March 11, 2026

Jon Shafer & The Resource Planning Team
NorthWestern Energy
IRP@northwestern.com

Comments on NorthWestern Energy's Draft 2026 IRP

FIGURE 35: NORTHWESTERN'S WINTER CAPACITY FORECAST.

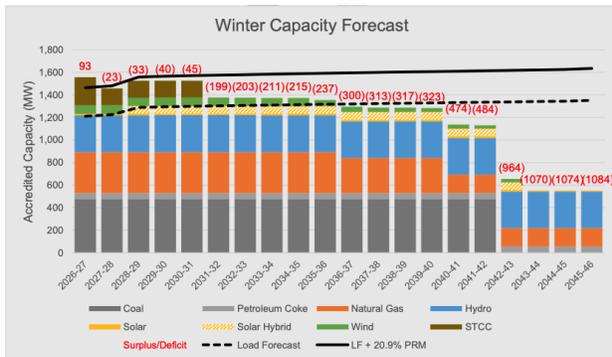
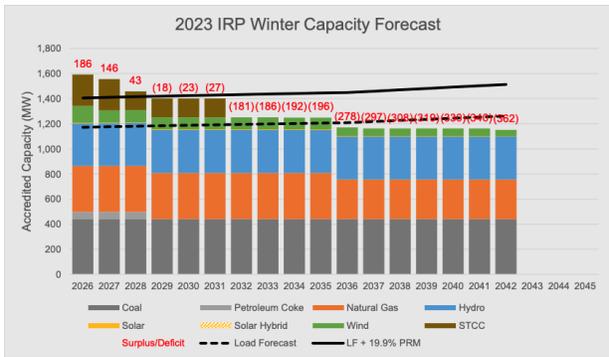
Comparing Figure 35, which shows the winter load forecast in the 2026 Draft IRP, with Figure 39, which shows the winter load forecast in the 2023 IRP, demonstrates an approximate 100-150 MW load forecast increase between the plans in the later years of the planning horizon. Since data center load growth is treated as its own sensitivity, this increased load forecast between the 2023 plan and 2026 plans seems to serve no purpose other than to show an inflated need for capacity investment.

MEIC’s concerns that the Draft IRP’s load forecasts and forecasted capacity need may be higher than is warranted are compounded by a [recent report](#) from GridStrategies. This report determined that the North American Electric Reliability Corp’s 2025 Long-Term Reliability Assessment, which is aggregated from individual utility and balancing authority projections, likely overestimates future load growth and ignores non-firm interregional power flows’ ability to contribute to capacity needs. These same national concerns are directly applicable to NorthWestern’s load forecasting and capacity need forecasting.

FIGURE 50: WINTER CAPACITY FORECAST WITH AN OVERBUILD CONSTRAINT.

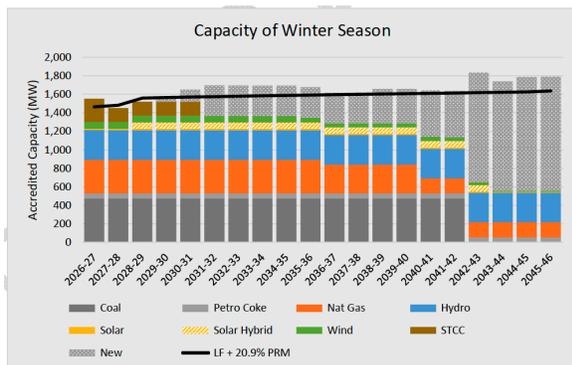
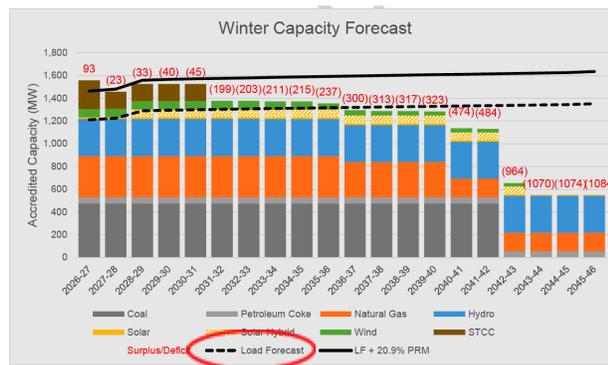
Whether or not the PRM percentages used in the Draft IRP come from WRAP, much more detailed explanation is needed on how these percentages are determined. The Draft IRP should explain and share what information NorthWestern shares with WRAP for calculating PRMs, as well as explaining WRAP's methodology for determining PRMs. Further explanation should also be provided as to why NorthWestern uses uniform seasonal PRMs rather than using

the more granular month-to-month PRMs provided by WRAP. Simply asserting that a 20.9% winter PRM means NorthWestern needs an additional 250 MW of accredited generation capacity in excess of its load forecast without any supporting justification is extremely troubling. Upon improving clarity around the PRM's used in the Draft IRP, the ARS capacity modeling result figures should be updated to show lines for load forecast without PRM in addition to LF + PRM lines, similar to the capacity need figures used earlier in the Draft IRP.
